CHEVROLET - CENTRAL OFFICE

TECHNICAL SERVICE BULLETIN

SUBJECT: HARDSTARTING - 1961 CORVAIR AND
CORVAIR "95" ENGINE - HOT WEATHER
OPERATION

BULLETIN NO. DR # 495

FIGURE 1 - SUMMER INSTALLATION

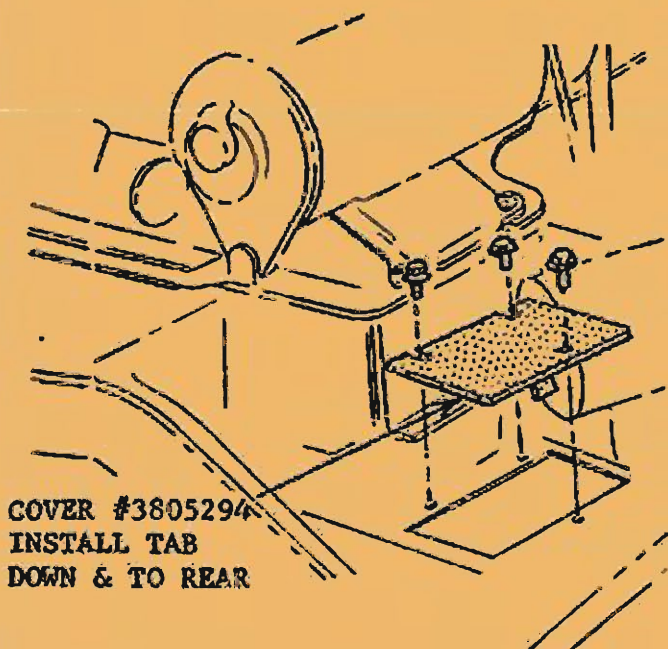
- A. On engines not equipped with a 60° baffle over the recirculation slots, install covers (Part #3805294) on both slots. Use 10-24 x 7/16" self tapping screws, pointing cover tabs down and to the rear as shown in Figure 1. Tabs are designed to hold damper doors open approximately 1 1/4 inches.

FIGURE 2 - COOLING DUCT ASSEMBLY R.H.

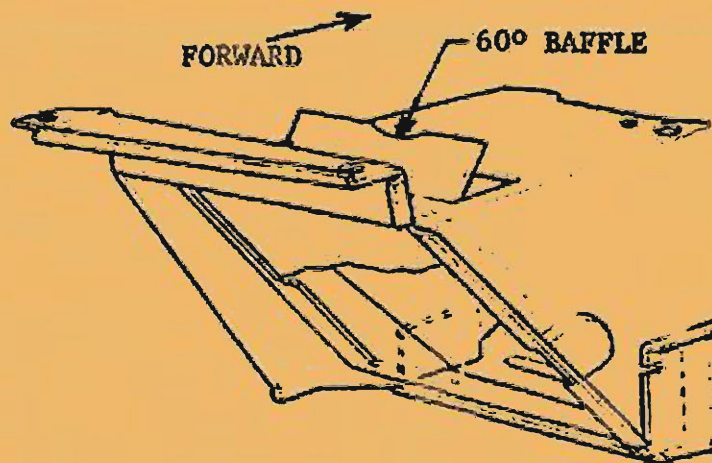
- B. On engines equipped with 60° baffles over the slots (Figure 2), bend the baffles to a closed position. This will seal off the slots sufficiently so that a cover is not required.
